Revised

EAGLE CREEK SUBDIVISION

APPLICATION NUMBER Holdover DATE September 2, 2004

DETAIL SITE PLAN

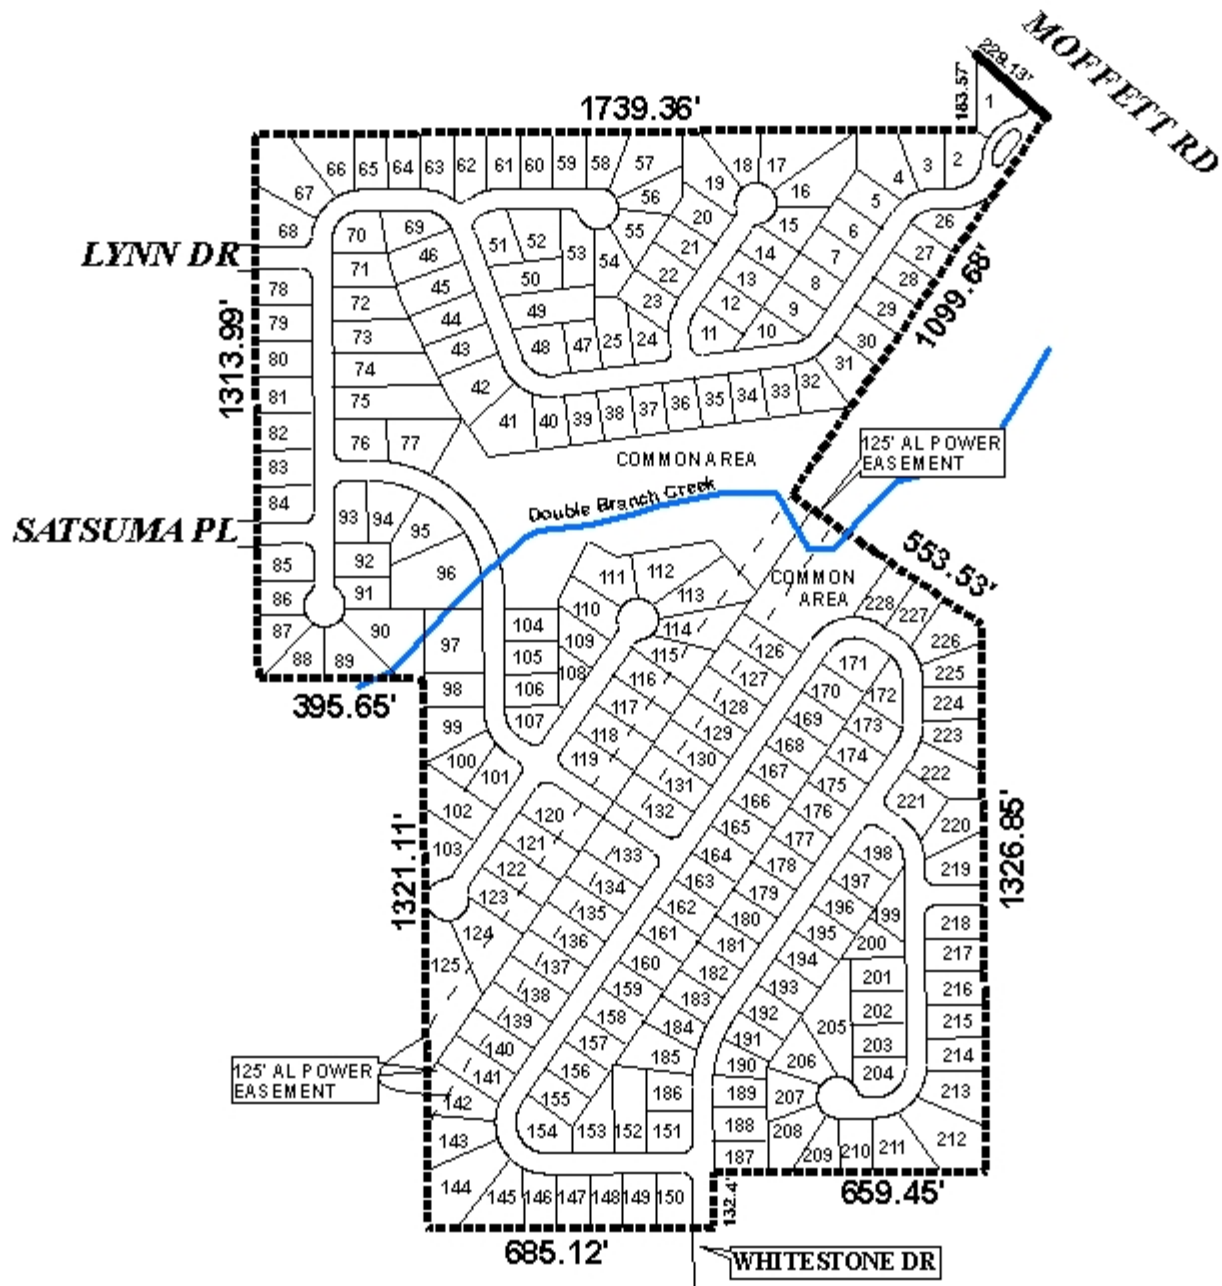
The proposed layout creates long "straight a ways" and traffic-calming devices should be provided in the areas of Lots 137 and 158, and 180 and 194; exact location and design of the traffic calming devices to be approved by County Engineering.

As shown on the Detail Site Plan, the street located between Lots 218 and 219 dead-end into the adjoining undeveloped property, thus the provision of a temporary turnaround should be required.

Common areas are shown on the plat, thus the placement of a note on the final plat stating that maintenance of the common area shall be the responsibility of the property owners, should be required.

The 25-foot minimum building setback lines are not shown but would be required on the final plat.

Satsuma Place and Lynn Drive are dirt roads. Therefore, a note should be placed on the final plat stating that direct access is denied until Satsuma Place and Lynn Drive are paved to County standards. This should include the construction of barricades for each road.

The plat meets the minimum requirements of the Subdivision Regulations and is recommended for Tentative Approval subject to the following conditions: 1) the dedication of sufficient right-of-way to provide 50' from the centerline Moffett Road; 2) the placement of a note on the final plat stating that Lot 1 is denied direct access to Moffett Road; 3) the provision of traffic calming devices in the area of Lots 138 and 152, and 180 and 194; exact locations and design to be approved by County Engineering; 4) the provision of a temporary turnaround between Lots 218 and 219; 5) all common areas be indicated on the final plat with a note stating that the maintenance thereof is the responsibility of the property owners association; 6) the placement of a note on the final plat stating that any lots which are developed commercially and adjoin residentially developed property must provide a buffer, in compliance with Section V.A.7. of the Subdivision Regulations; 7) the approval of all applicable federal, state and local agencies prior to the issuance of any permits; 8) the placement of the 25-foot minimum setback lines on the final plat; and 9) the placement of a note on the final plat stating that direct access is denied to Satsuma Place and Lynn Drive until paved to County standards.
